State Planning Commission

ASSESSMENT REPORT

MOUNT LOFTY GOLF ESTATE AND RESORT

Mount Lofty Golf Estate Pty Ltd

Figure 11 – Identified shoulder sealing zones along Golflinks Road (Source CIRQA)

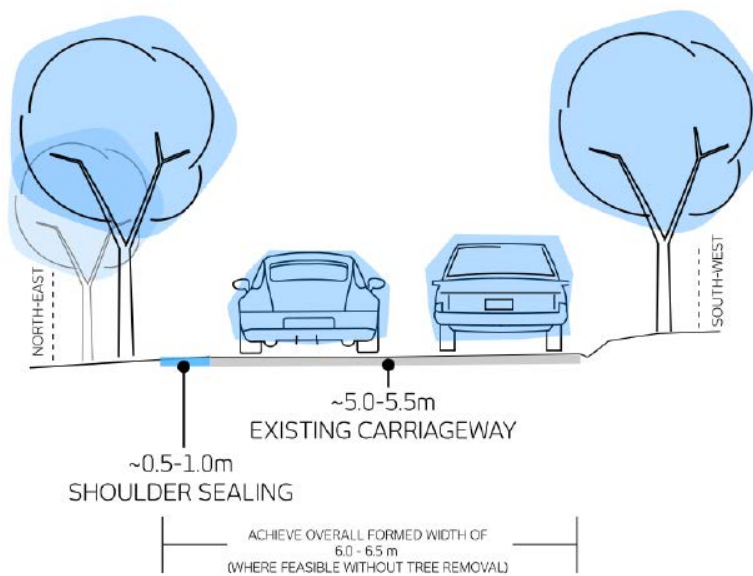
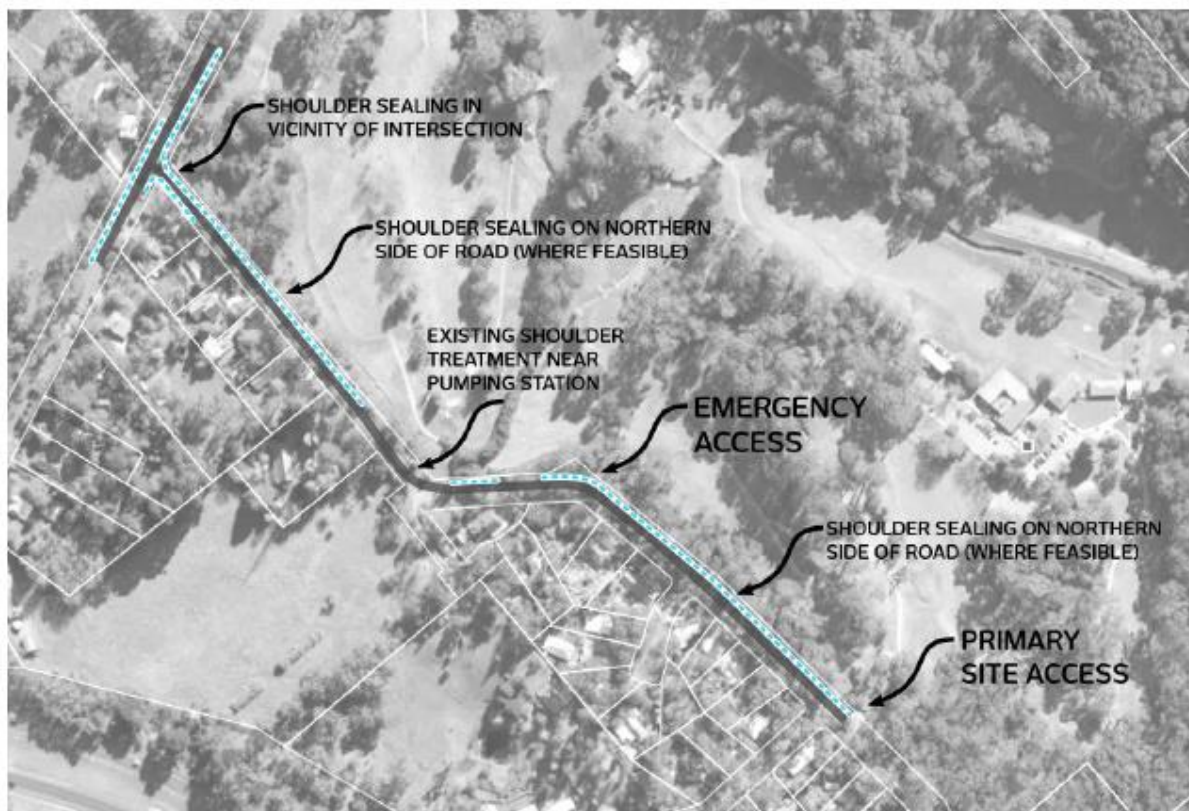
Further consideration could be given widening (in the form of shoulder sealing / improvement) along Golflinks Road in specific locations. Council is not opposed to these works, subject to detailed engineering designs that take account of existing service and infrastructure locations, and where vegetation impacts can be minimised.

From a safety perspective, however, some vegetation removal (including trees that are clearly dead), would be warranted to improve the safety and trafficability of Golflinks Road where shoulder sealing was identified as being beneficial and necessary. The speed limit at the site access from Old Carey Gully Road is also recommended to be changed from 80km/h to 60 km/h.

Council requested additional swept paths and further modifications to the intersection to Old Carey Gully Road, Golflinks Road and Golflinks Close for manoeuvrability of 19m articulated vehicles. Further details / modifications include road widening in front of 26 Golflinks Road; a swept path analysis for a 19m articulated vehicle at all intersections (minimum clearance of 300mm); and the upgrade of the Davenport Road access and associated works, including drainage crossings, road build-up, and asphalt widening, must comply with Council' standards.
